Access Compliance Report

Public Rights-of-Way

(Curb Ramps)

Intersection ID: 44305	Main Street: VALERIE_DR	Cross Street: MALLORY_TAYLOR_LN	Location: SE
ADA ID: 03C76BCBBC8D	Ramp Type: BlendTrans1	Initial Pass/Fail: Fail	Overall Compliance: No
		Severity Score: 10

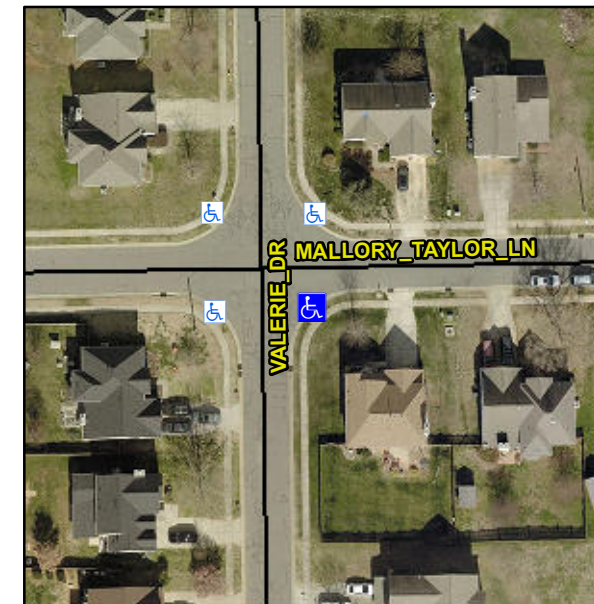
Not Found, R304.5.1, R304.5.3

Compliance	Description	Data	Compliance	Description	Data
N/A	Ramp Length (in)	49.0	Yes	BlendTrans Slope (%)	4.1
No	Ramp Width (in)	45.5	No	BlendTrans XSlope (%)	4.1
N/A	Flare Type LT	N/A	N/A	Flare Type RT	N/A
N/A	Flare Slope LT (%)	N/A	N/A	Flare Slope RT (%)	N/A
N/A	Flare Traversable LT?	N/A	N/A	Flare Traversable RT?	N/A
N/A	Landing Length (in)	N/A	N/A	DWS Provided?	N/A
N/A	Landing Width (in)	N/A	N/A	DWS Contrast?	N/A
N/A	Landing Slope (%)	N/A	N/A	DWS Length (in)	N/A
N/A	Landing X Slope (%)	N/A	N/A	DWS Full Width?	N/A
N/A	Landing Curb? (Y/N)	N/A	N/A	DWS Offset (in)	N/A
N/A	Shared Landing?	N/A			
N/A	Gutter Ponding?	N/A	N/A	Gutter Slope (%)	N/A
N/A	Gutter Lip Ht (in)	N/A	N/A	Gutter X Slope (%)	N/A
N/A	Painted X Walk1?	No	N/A	Painted X Walk2?	No
	X Walk 1 Direction	To N		X Walk 2 Direction	To W
	X Walk 1 Width (in)	N/A		X Walk 2 Width (in)	N/A
	X Walk 1 Slope (%)	2.0		X Walk 2 Slope (%)	0.6
	X Walk 1 X Slope (%)	2.0		X Walk 2 X Slope (%)	1.3

N/A	Ramp inside XWalk1?	N/A	N/A	Ramp inside XWalk2?	N/A
	Road Slope (%)	3.1		Clear Space?	N/A
	Road X Slope (%)	2.2	N/A	Clear Space to XWalk (in)	N/A
N/A	Any Obstructions?	N/A	N/A	Storm Grate/Utility Hazard?	N/A
	Obstruction Type			Storm Grate/Utility Type	
		N/A			N/A
			Yes	Surface Condition? (G/P)	Good
			No	Curb Slope (%)	16.2

Remove & Replace Curb Ramp With Two New Directional Ramps or Equivalent.
